ADDENDUM NO. 05

PROJECT: South Orangetown Central School District
PHASE 2: 2022 BOND

CPL PROJECT NO. 14457.20

DATE: November 19, 2024

1
H100G
1/8" = 1'-0"
CRAWL SPACE PIPING DEMOLITION PLAN - AREA G1

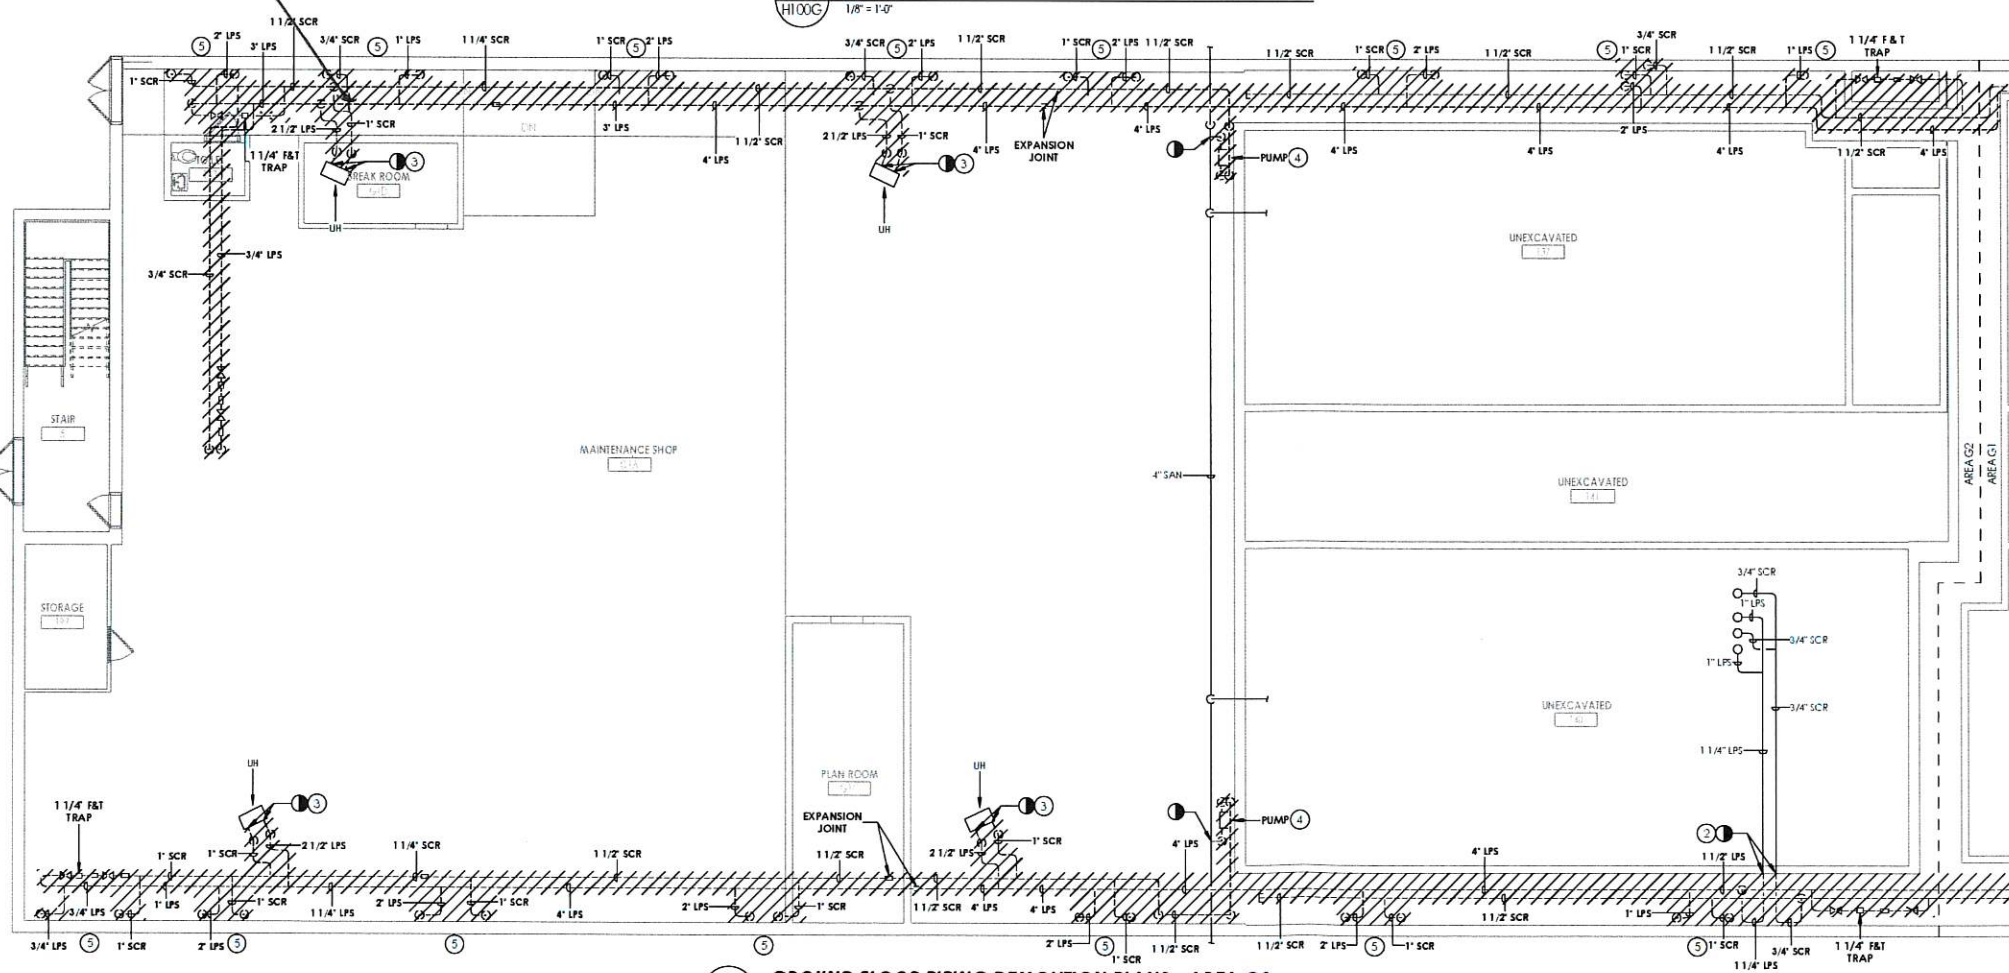
- 2.12 Specification Section 012300 ALTERNATES:
 - a. Part 3, Item 4.01, B: After MC-01 ADD:
 - Alternate No. MC-02: PIPE REMOVAL IN TUNNELS**
 - a. Base Bid: Demolish all steam piping as shown on Drawing H100G

- b. Alternate: All steam piping on Drawing H100G shall be cut at the main, capped and abandoned in place. Branches to the unit heaters shall be removed back to the main and capped.

8 EQUIPMENT HOUSE KEEPING PAD
 NOT TO SCALE
 A800

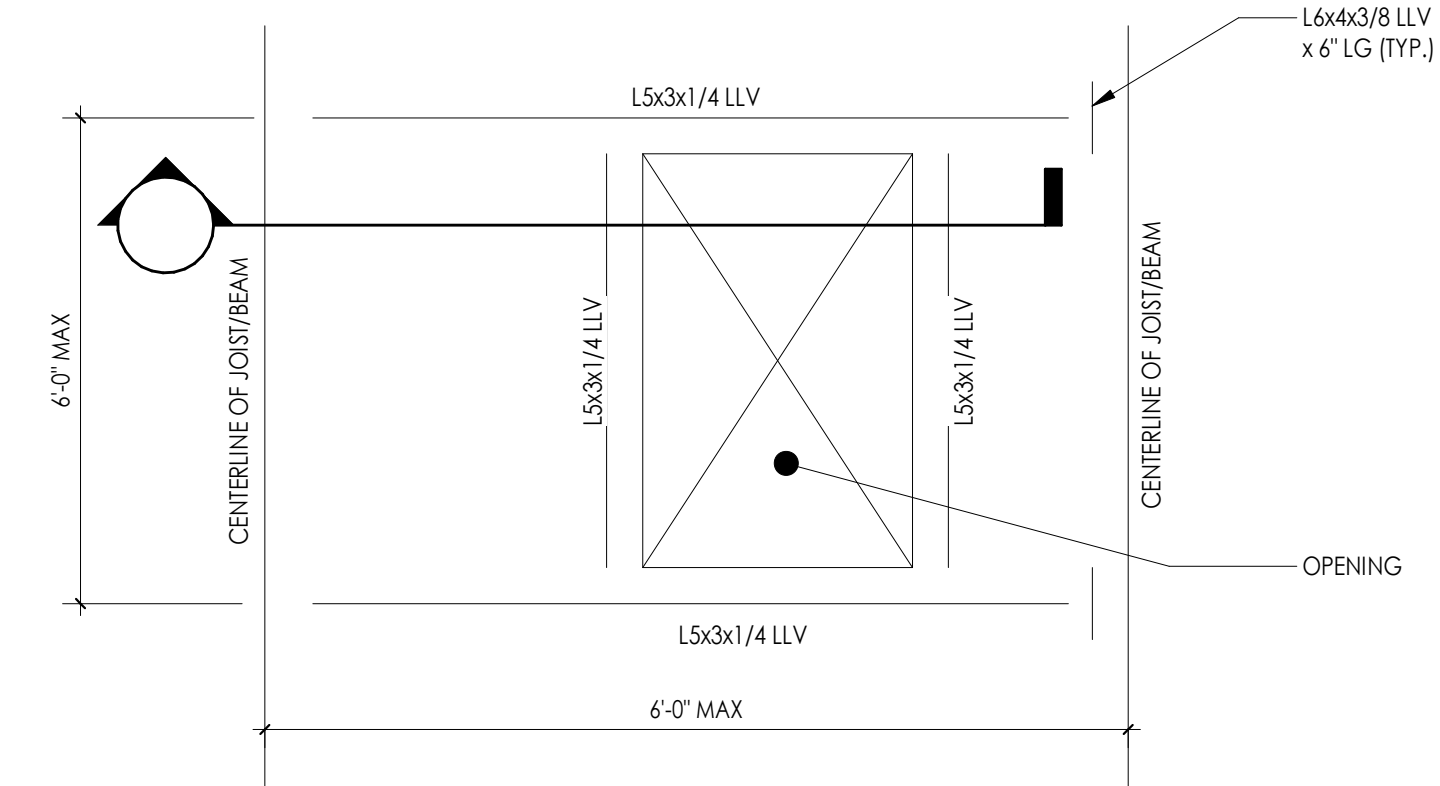
MESSAGE: Refer to Mechanical DWG H802; Detail 3 shows concrete pad. Please clarify if GC or M.C. is responsible for these pads?

- 3.23 Drawing H802: OMIT DETAIL 3. EQUIPMENT HOUSE KEEPING PAD
- 3.24 Drawing H902: Replace with attached revised H902.
- 3.25 Drawing P000:
 - a. OMIT 5/P000, TYPICAL SINK FIT-UP DETAIL
 - b. PLUMBING EQUIPMENT & FIXTURE SCHEDULE:
 - i. OMIT SK-1
 - ii. OMIT SK-2
- 3.26 Drawing P101:
 - a. OMIT 2/P101 DEMOLITION PLAN – AREA C2
 - b. OMIT KEYNOTES 1, 2 & 3
- 3.27 Drawing P201:
 - a. OMIT 1/P201 INSTALATION PLAN – AREA C2
 - b. OMIT KEYNOTE 1
- 3.28 Drawing E102: Replace with attached revised E102
- 3.29 Drawing E202: Replace with attached revised E202
- 3.30 Drawing E302: Replace with attached revised E302
- 3.31 Drawing T101: Replace with attached revised T101
- 3.32 Drawing T201: Replace with attached revised T201

A801 1 1/2" = 1'-0"

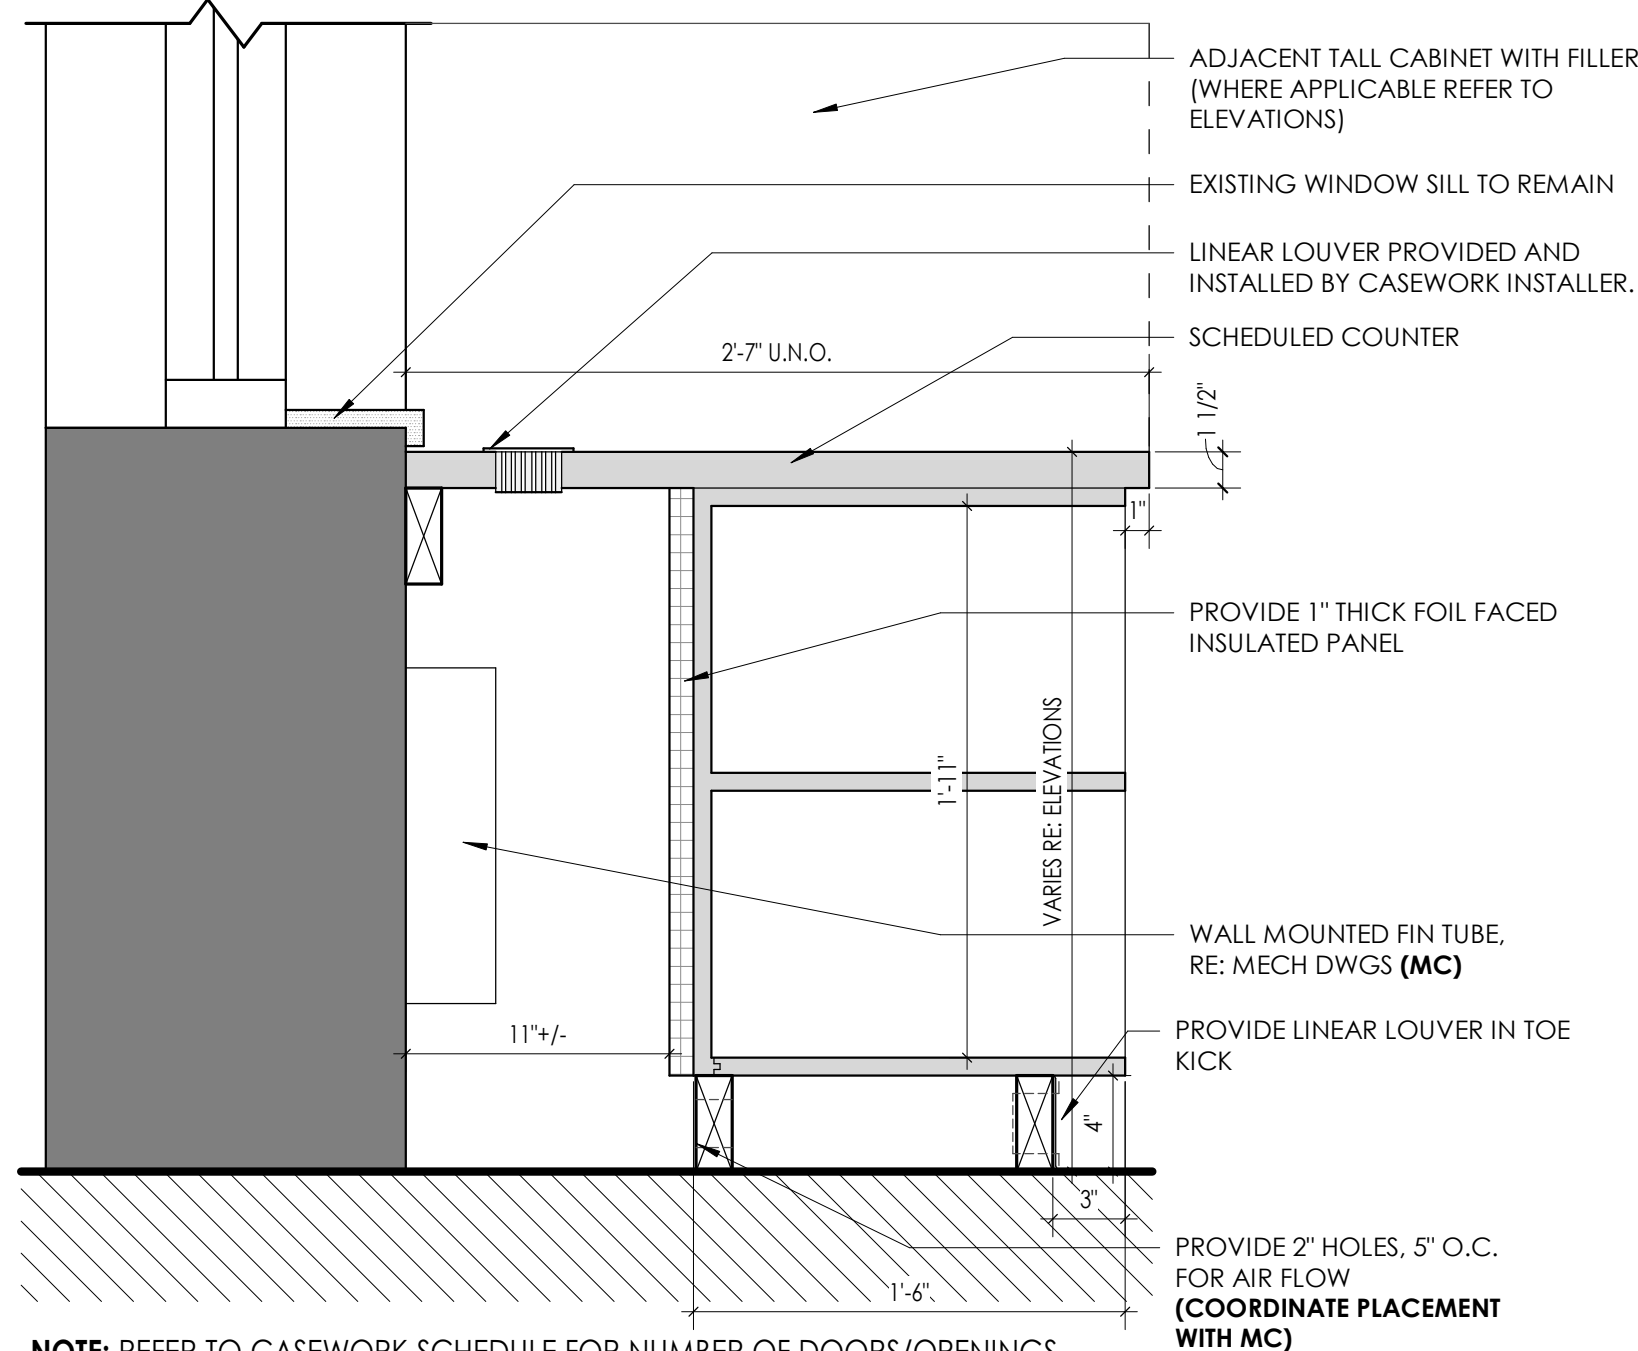
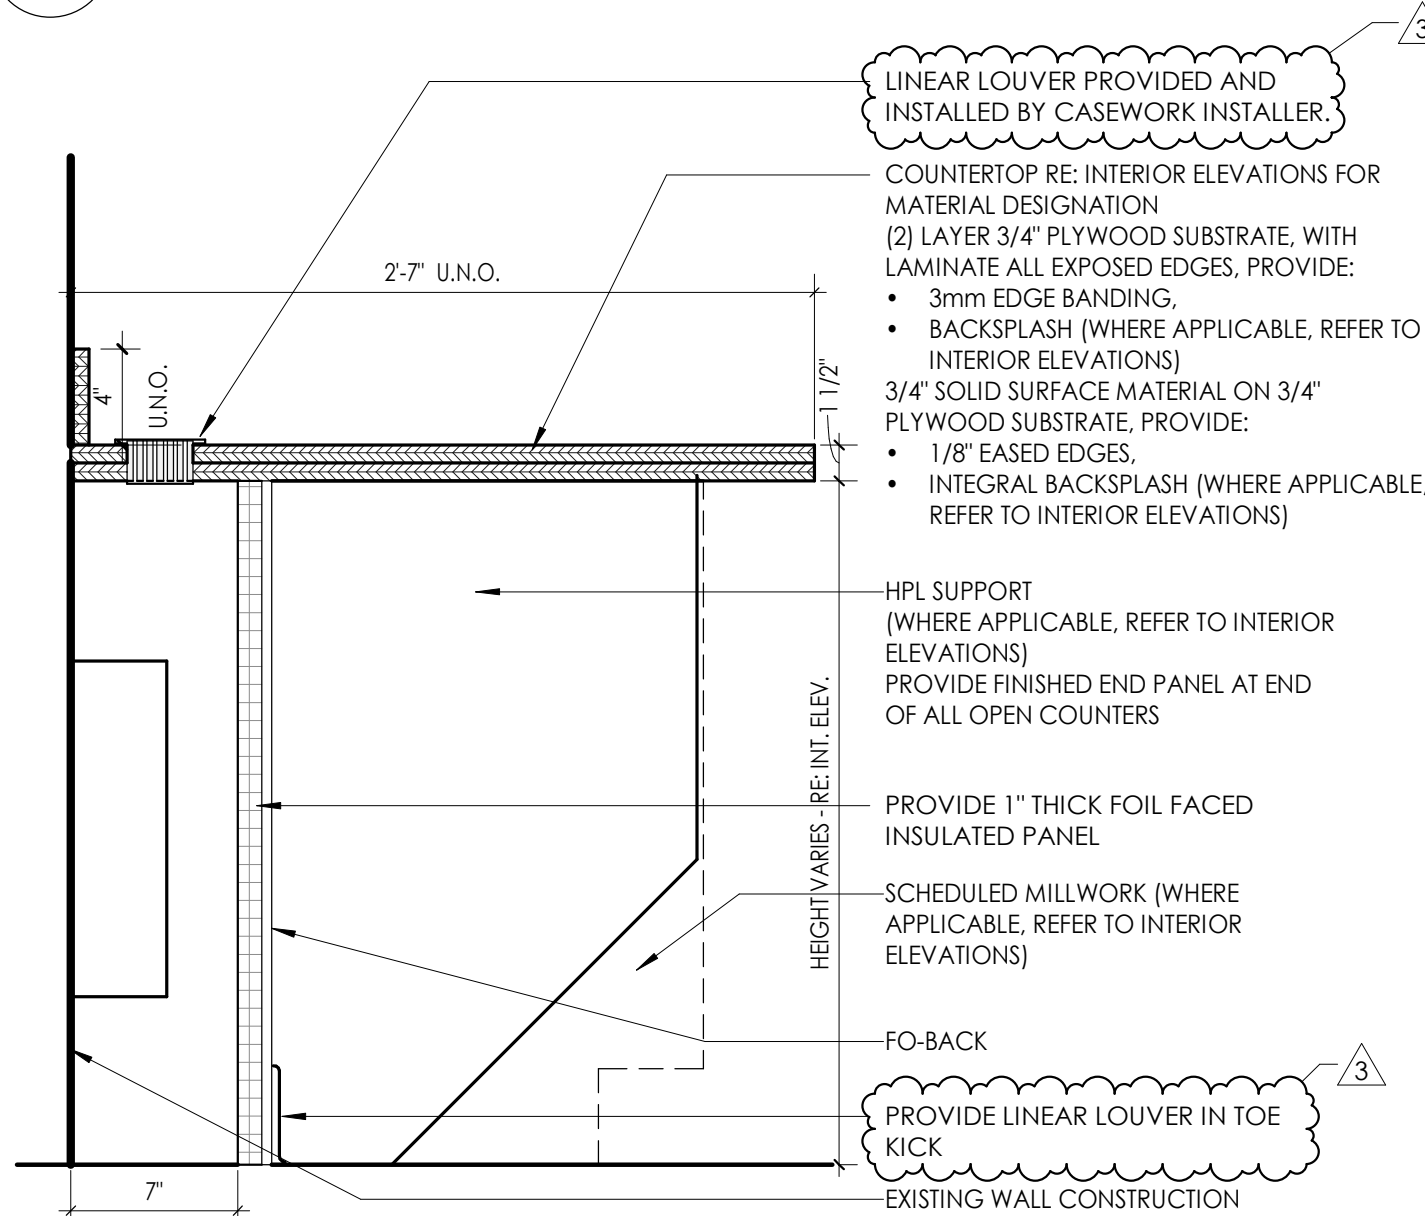
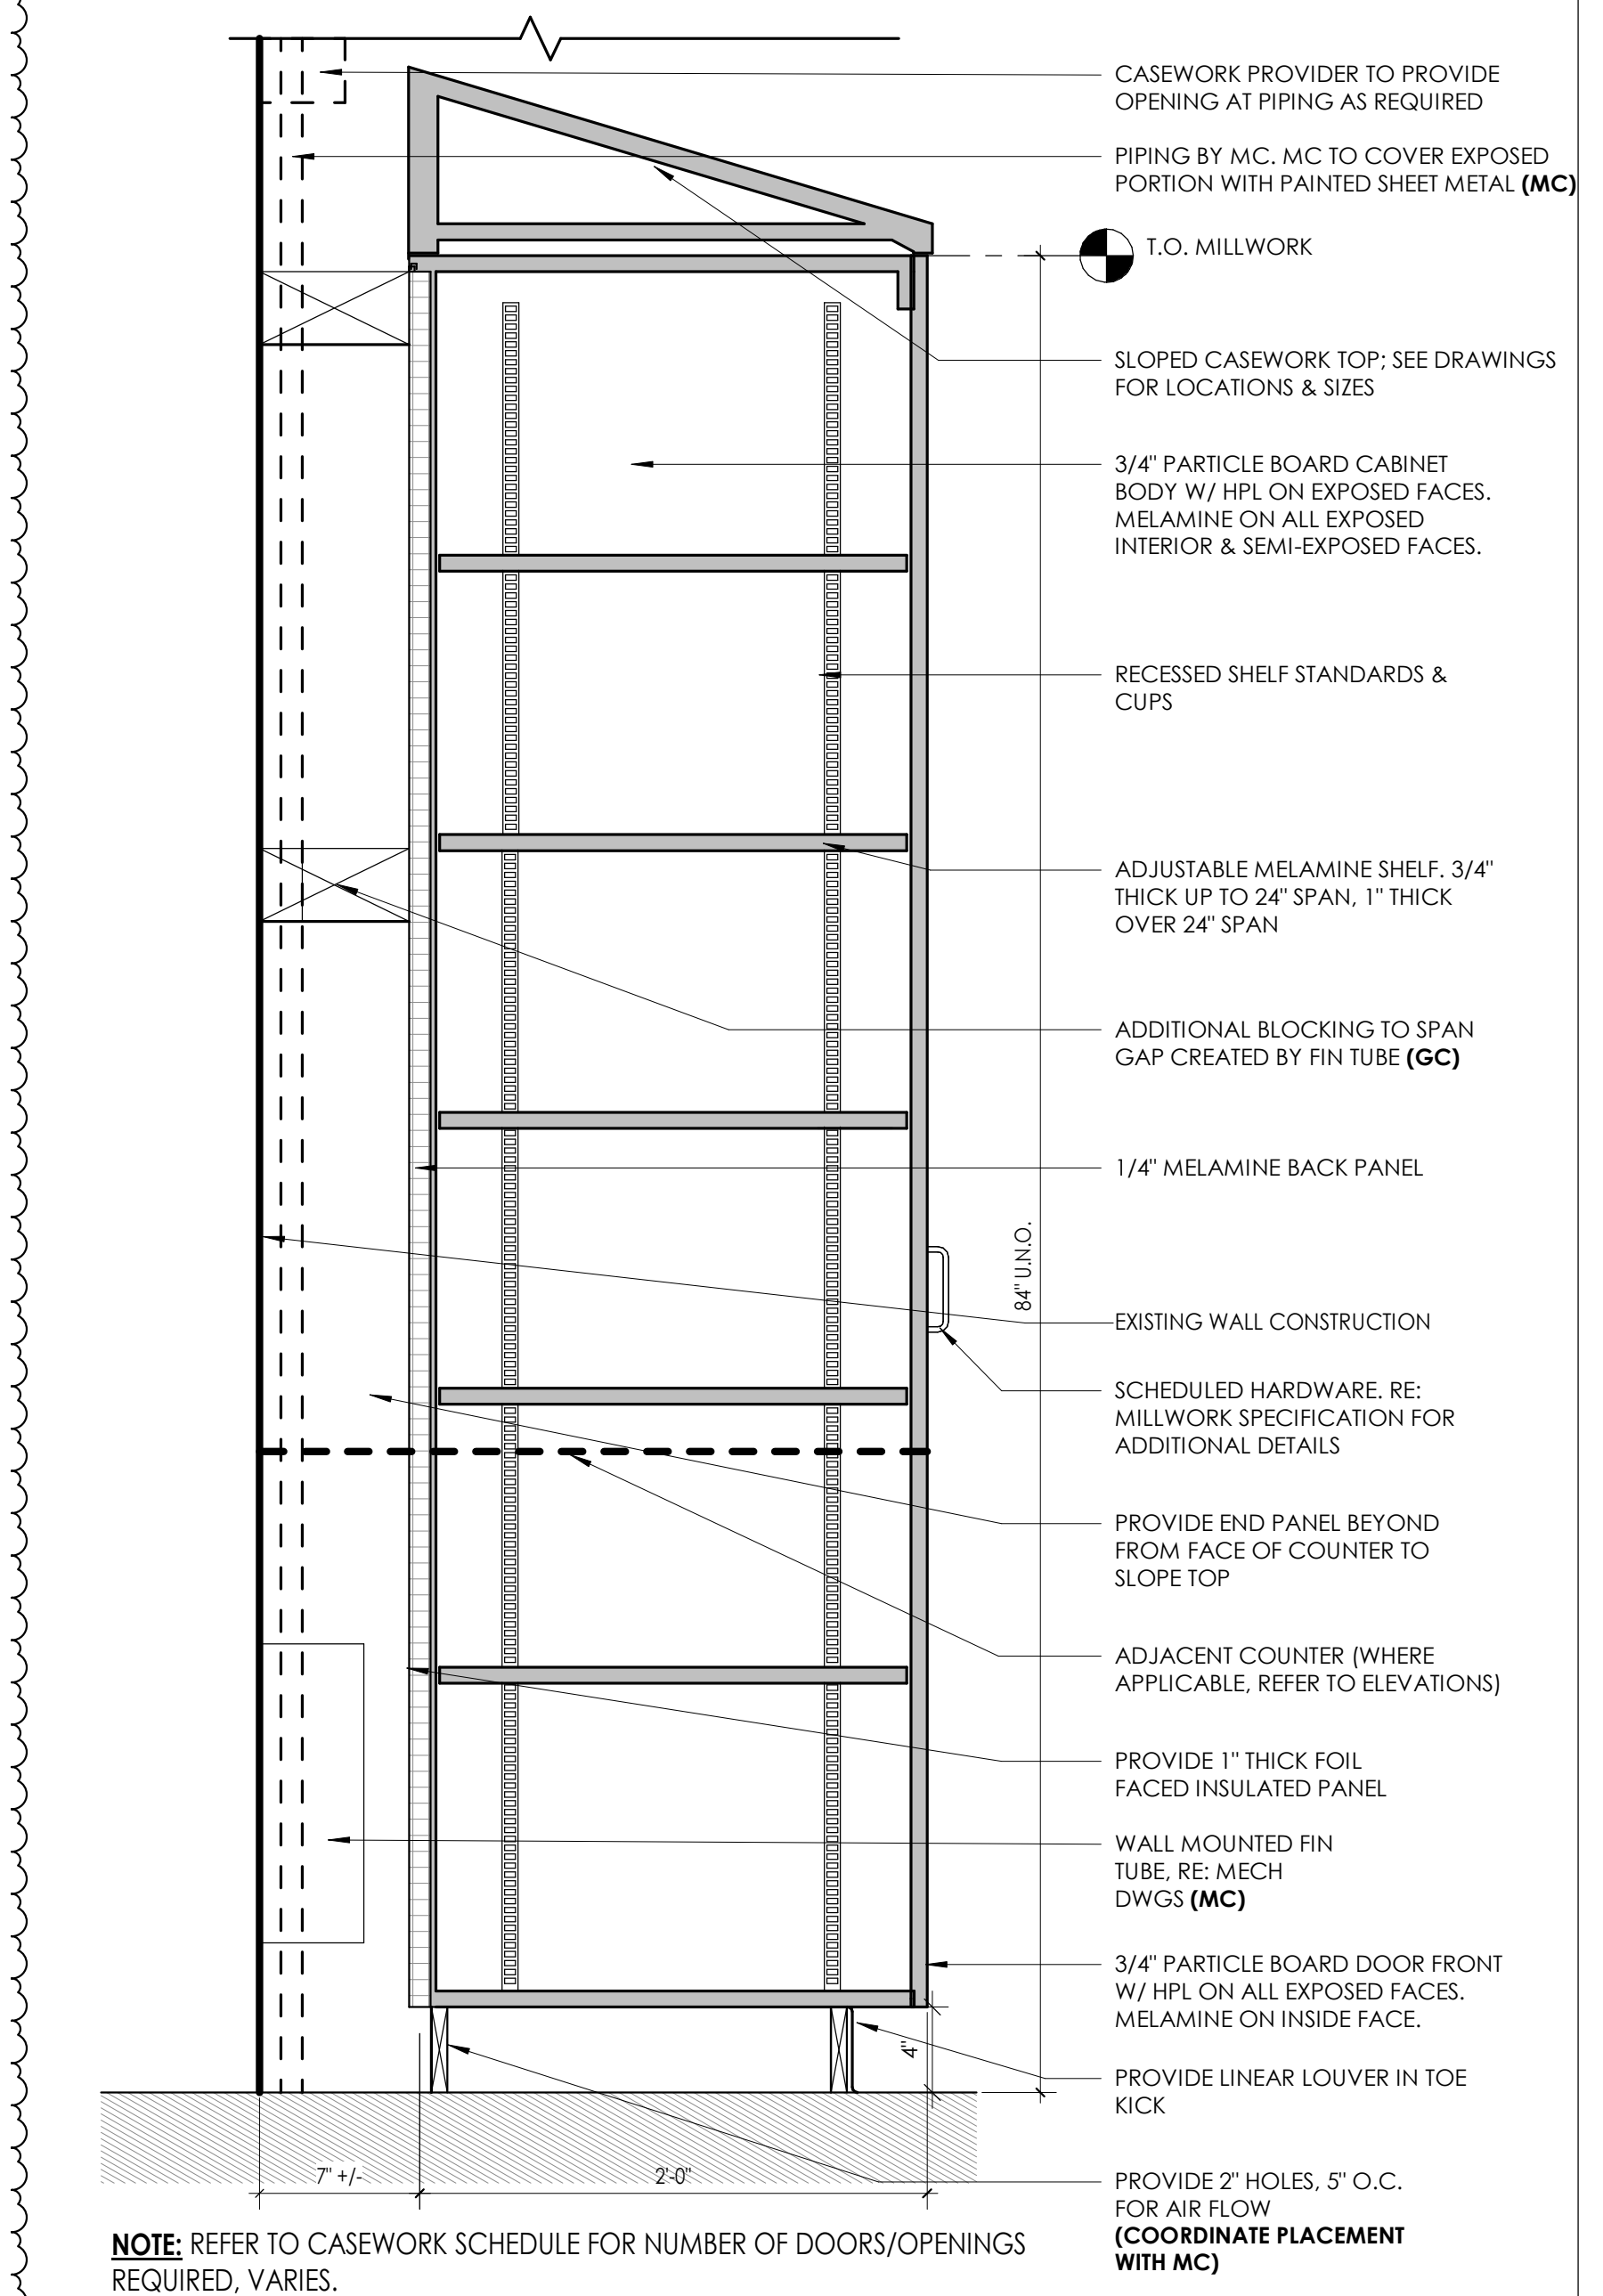
As per Dtl. 7/A801; laminate counter is by casework contractor however interior finish schedule on I000 shows Solid surface material (SSM-1) by GC. Please clarify who is responsible for solid surface material (SSM-1)?

CONFIRMED - ALL CASEWORK SHOWN IS BY OWNERS CASEWORK CONTRACT, NOT BY GC. REFER TO ADDENDUM #5 FOR REVISED A801 AND I000.
